Proposal for Supplement 6 to the 05 series of amendments to Regulation No. 49 (compression ignition and positive ignition (LPG and CNG) engines) - document ECE-TRANS-WP29-GRPE-2013-07e

Amendments and complements to be taken into consideration

“Figure 14

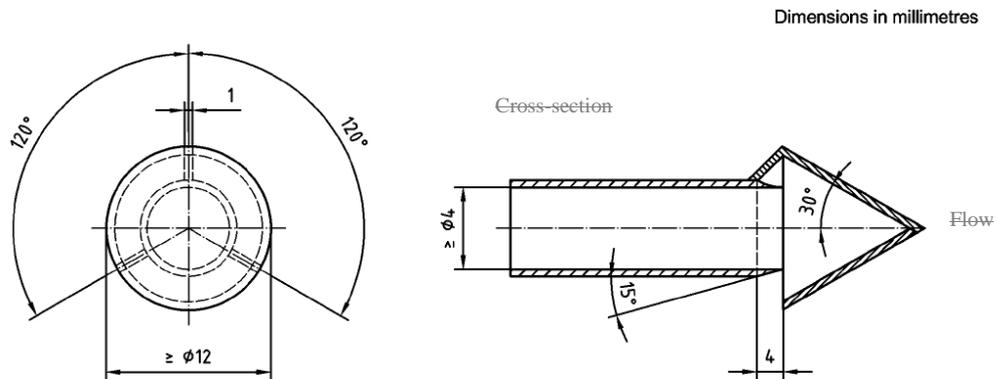
Annex 4B, Appendix 3, Figure 14, amend to read:

Scheme of hatted probe

“Figure 1
Illustration of the HC limits in the case of a Type 2B dual-fuel engine operating in dual-fuel mode during the ETC cycle (natural gas dual-fuel engines)

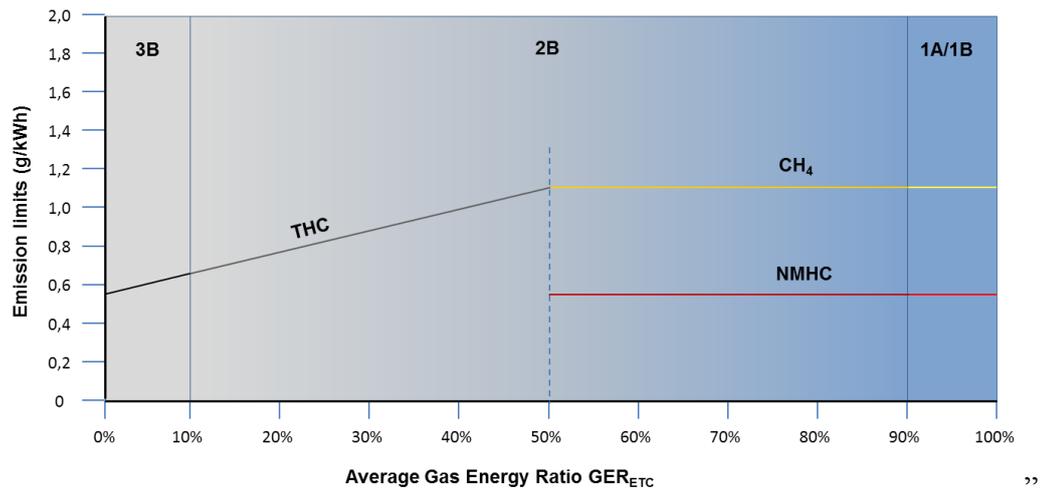
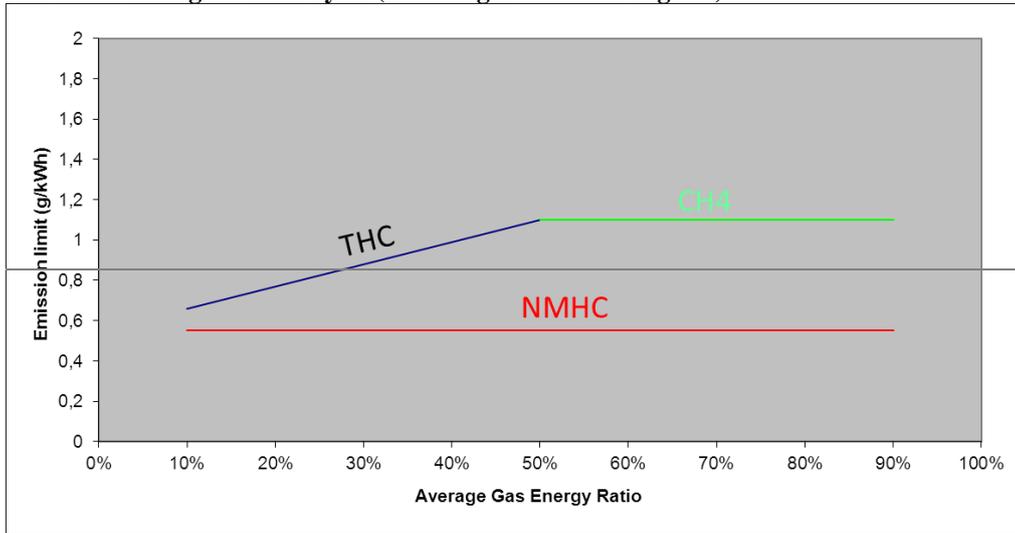
Annex 11, section 5.2., figure 1, title and figure, amend to read:

- 5.2.3. Calculation procedure to determine the hydrocarbon limits (in g/kWh) applicable to Type 2B dual-fuel engines operating in dual-fuel mode during the ETC test cycle.

- The following calculation procedure applies to Type 2B dual-fuel engines tested over the ETC cycle while operating in dual-fuel mode :
- Calculate the average gas ratio GER_{ETC} over the ETC test cycle

- Calculate a corresponding THC_{GER} in g/kWh using the following formula:
- $$\text{THC}_{\text{GER}} = \text{NMHC}_{\text{NG}} + (\text{CH}_4_{\text{NG}} * \text{GER}_{\text{ETC}})$$

Determine the applicable THC limit in g/kWh using the following method:

If $\text{THC}_{\text{GER}} \leq \text{CH4}_{\text{NG}}$, then

- (a) THC limit value = THC_{GER} and
- (b) No applicable CH_4 and NMHC limit value

If $\text{THC}_{\text{GER}} > \text{CH4}_{\text{NG}}$, then

- (a) No applicable THC limit value; and
- (b) Both the NMHC_{NG} and CH4_{NG} limit values are applicable.
